NUCLEAR ENERGY INSTITUTE

SUBJECT: Draft Regulatory Guide DG-1081, *Alternative Radiological Source Terms for Evaluating Design Basis Accidents at Nuclear Power Reactors*, (64 Fed. Reg. 71990)
Request for Comments

Enclosed are the Nuclear Energy Institute's (NEI)¹ comments on draft Regulatory Guide DG-1081, issued for public comment on December 23, 1999. Also included are comments on the associated Standard Review Plan section 15.0.1.

COMMENTS ON DRAFT DG-1081 AND DRAFT SRP

Figure A-1: Measurements of Fission Gas Content in LWR Fuel Rods

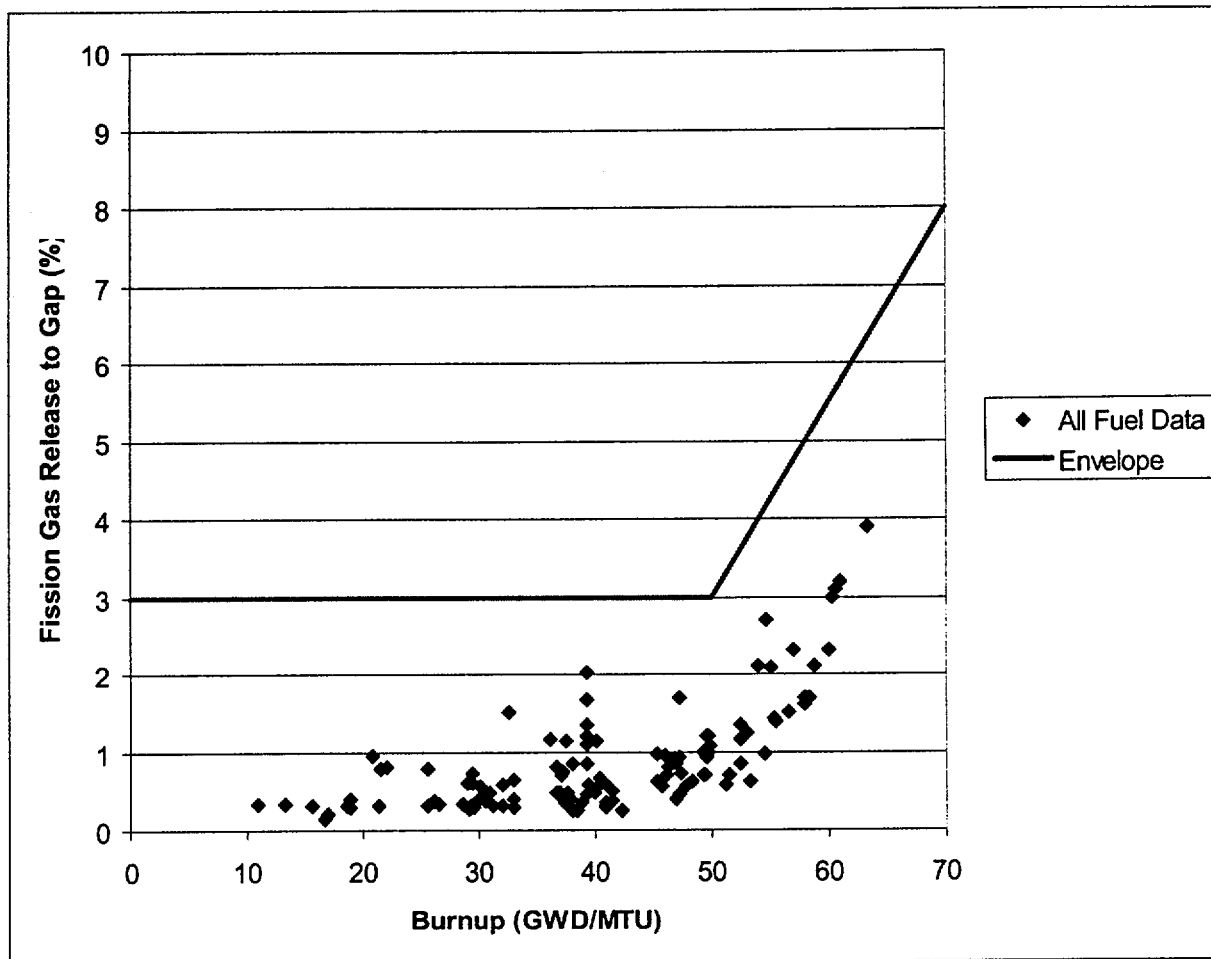
The combined data of references [2-4] show that fission product release is less than 1.0% up to a burnup of about 30,000 MWd/MTU. As the burnup increases, the gap fission product content increases to about 2% at 40,000 MWd/MTU. At about 50,000 MWD/MTU, the gap fraction increases with burnup at a rate of about 2.3% per 10,000 MWd/MTU per reference [2]. In the table below, the middle column shows an envelope of the data. The right-hand column of the table shows the industry recommended gap fractions for use in analyzing non-LOCA events. The degree of conservatism of this proposed envelope relative to the data is illustrated in Figure A-1.

A bounding envelope that industry proposes to use for the safety analyses was drawn over the data with margin added for conservatism. Industry believes that the bounding envelope is conservative for the following reasons:

- The envelope is drawn well above all data (approximately 100% margin above the mean values and 50% margin above the maximum values).
- The xenon plus krypton release percentage would be applied to iodine isotopes, which would be conservative since iodine is less volatile than xenon and krypton.

Industry proposes that DG-1081 be changed to specify that for postulated accidents which may have damaged fuel but do not have a fuel heatup, licensees should utilize the gap fractions as a function of burnup as specified in the right-hand column of the above table.
